Subject: Consolidated City of Toronto Comments
Request for a Minister's Zoning Order for Affordable Housing and
Mixed-use Development in the City of Toronto
ERO #: 025-0118
1635 Lawrence Avenue West

These comments are in reference to the Environmental Registry of Ontario (ERO) posting regarding a request for a Minister's Zoning Order (MZO) to permit a multi-tower mixed-use development containing affordable housing located at 1635 Lawrence Avenue West in Toronto.

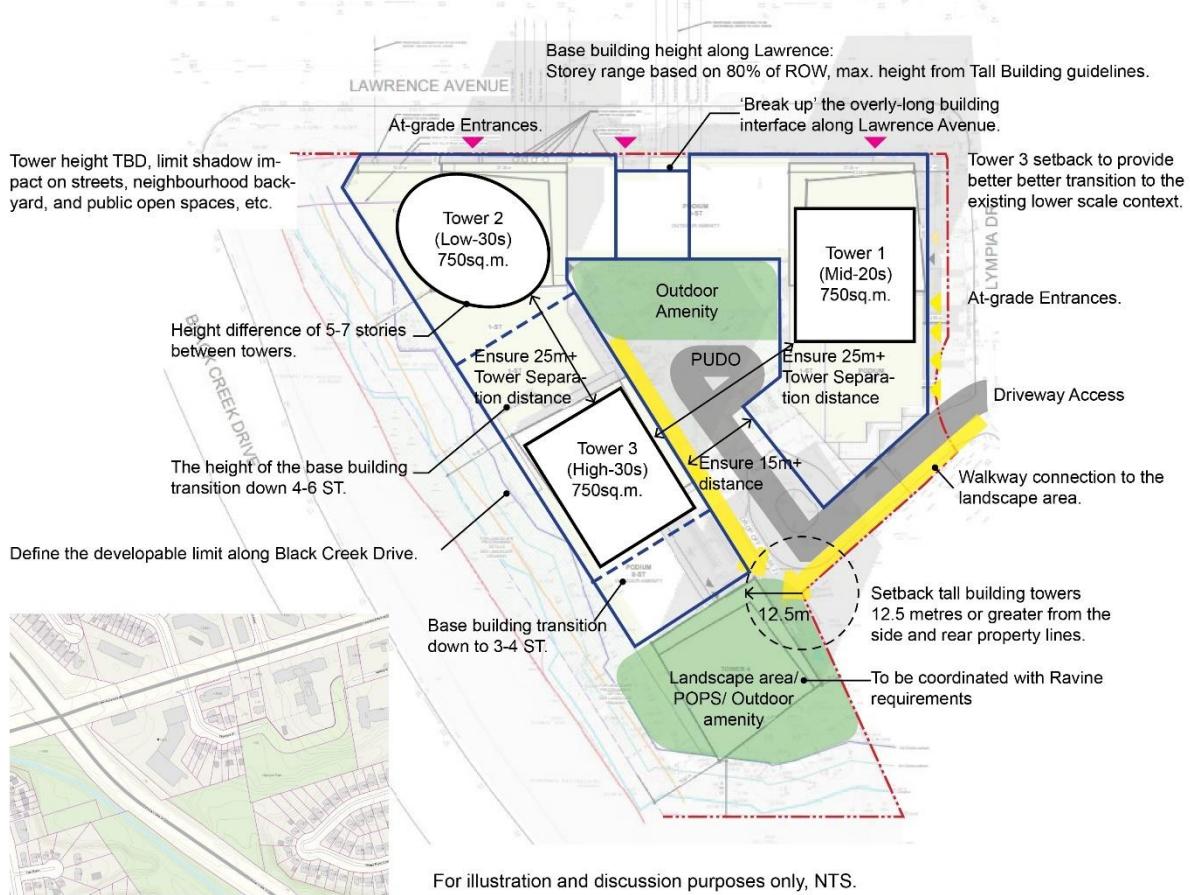
60. The City previously provided a site plan layout and massing option for the proponent to consider through the Pre-Application Consultation checklist issued March 14, 2024, incorporating key comments and markup below:

- a. The number and height of towers should be reduced to better fit the existing and planned context, ensure appropriate transitions in scale, and maintain sunlight and daylight access throughout the site, proposed amenities, and surrounding public realm.

- b. Suggested tower heights for three-tower concept are as follows: Tower 1 – mid-20s storeys, Tower 2 – low-30s storeys, and Tower 3 – high-30s storeys. A height difference of 5 to 7 storeys between adjacent towers for height variance should be provided.

- c. A minimum 3 metre tower setback from the base building should be provided.
 - d. Floorplate sizes of the proposed tower floor plates and the separation distance between all towers should be clarified.

- e. The lack of tower setbacks from the abutting east Mixed Use Areas site, which has additional tower potential, must be addressed, as well as setbacks from the southeast lot line in accordance with the Tall Building Design Guidelines.

- f. The east tower should be shifted further back from the street frontage to improve the transition to the existing lower-scale context.
 - g. The base building heights should align with the Tall Building Design Guidelines, incorporating a massing transition from the prominent intersection of Black Creek Drive and Lawrence Avenue West to the adjacent natural heritage lands.

- h. Articulation should be introduced to break up the overly long building frontage.

- i. The servicing area within the built form should be internalized to minimize visual impact on the public realm and enhance pedestrian safety.
- j. The central amenity space should be revised, as its current location remains in shadow all day, which is not acceptable.
